Landscape Peer Review

Ayrburn Screen Hub

17 December 2025 | FINAL

- 1.1 Bridget Gilbert Landscape Architecture Limited (**BGLA**) has been requested by Queenstown Lakes District Council (**Council**) to undertake a Landscape Peer Review of an application by Waterfall Park Developments Limited under the Fast Track Approvals Act 2024 to develop the Ayrburn Screen Hub, a production facility featuring two studios, accommodation, and supporting facilities and amenities (**the proposed development**).

Figure 2: Proposed Ayrburn Screen Hub Masterplan with the Ayrburn Structure Plan overlaid (Source RMM Addendum, Figure 1).

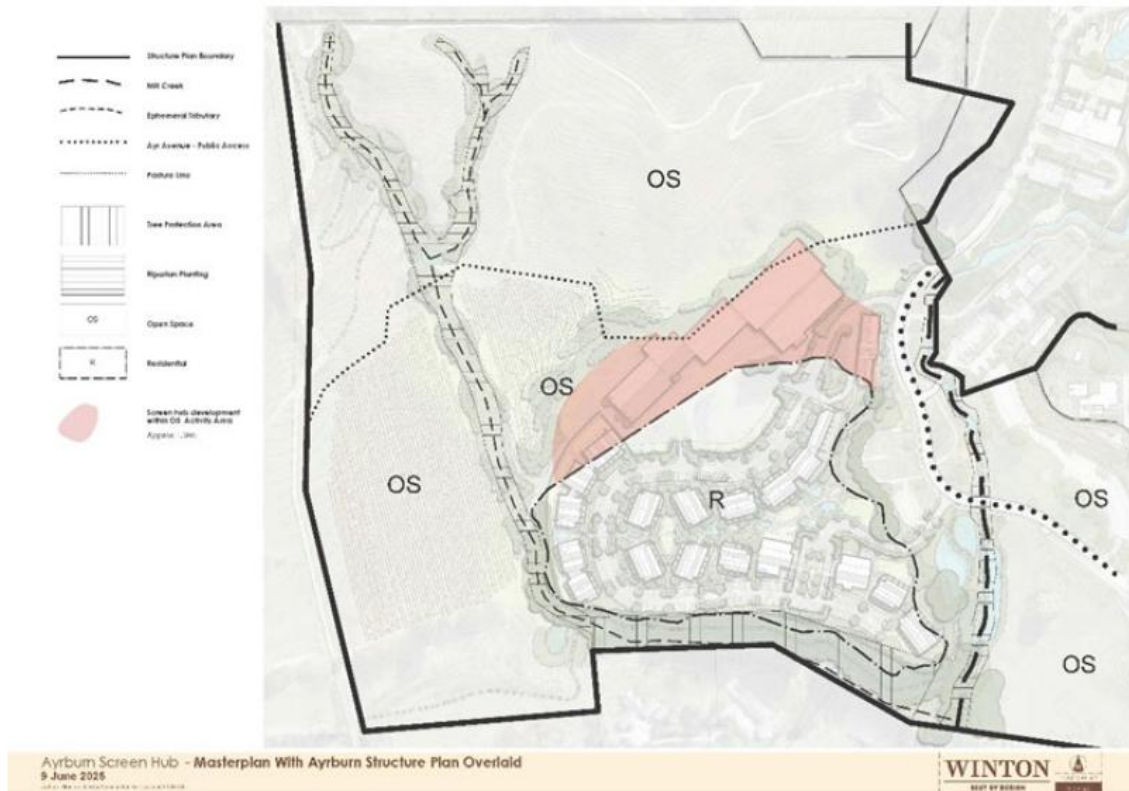
- 5.22 I agree that the majority of the proposed development change is located within a part of the ASP where rural living development is enabled and only a relatively small portion of the OSA (approximately 1.5ha) is impacted, with that area of OSA having a relatively low visual profile excepting in relation to views from the Countryside Trail/Te Araroa.
- 5.23 However, I consider that the very different development typology associated with rural living development versus the urban scale, character, intensity, and appearance of the proposed development renders these spatial 'characteristics' to be of limited influence in moderating landscape effects.

Figure 1: Appendix 20 Proposed Contour Overlay Plan (red linework) overlaid on Existing Contours (black linework)

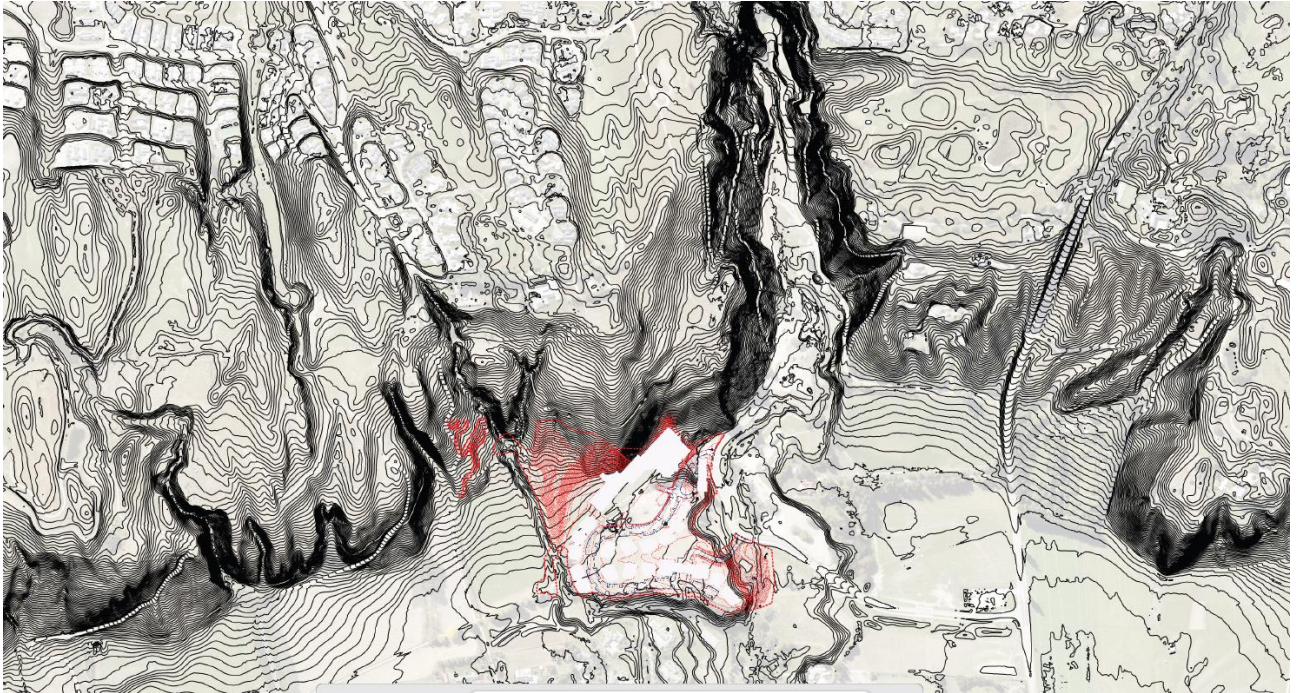
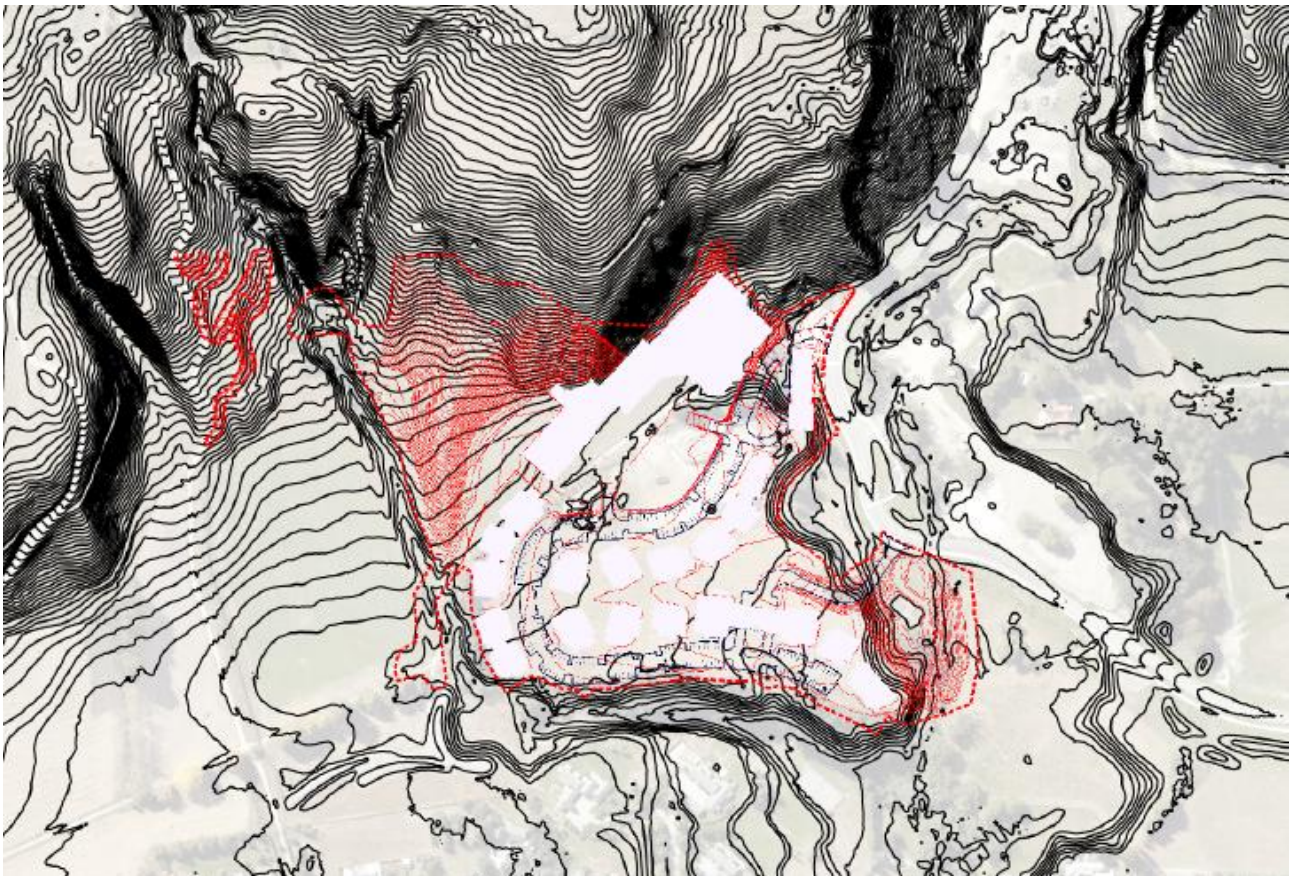
- 4.4 In terms of the earthworks cut and landscape strategy along the northwestern side of the site I note that the Appendix 20 Proposed Contour Overlay Plan advises that the final cut batter grade behind (or to the north of) the film studio buildings is "subject to detailed design", and that there is "provision for soil nails in this area". In my experience, soil nails are typically used in combination with shotcrete, geotextile membrane or steel mesh which may make the planting proposed in this area practicably infeasible. In a similar vein to my comments in relation to the stabilisation of the spur landform, I do not consider that it is appropriate to leave the design of this aspect of the project to the detailed design stage because, depending on the design solution proposed, this aspect of the development may be of such a scale and/or character (including precluding the proposed native margin planting) that it creates adverse landscape effects or reduces the landscape mitigation benefits of the development.

- 4.6 In reviewing the earthworks aspects of the proposal, I have also noticed a potential discrepancy between the Appendix 20 Depth Contour Plan and the Existing Contours Plan/Proposed Contour Overlay Plan. For the purposes of my peer review, I have assumed that a sympathetic 'marrying in' of the new spur landform with the existing contours will be detailed in any final development plans should the Panel be minded to grant consent.

- 4.5 For the purposes of my peer review, I have assumed that a sympathetic retaining system can be designed that allows for the successful establishment of the plantings intended in this part of the development.
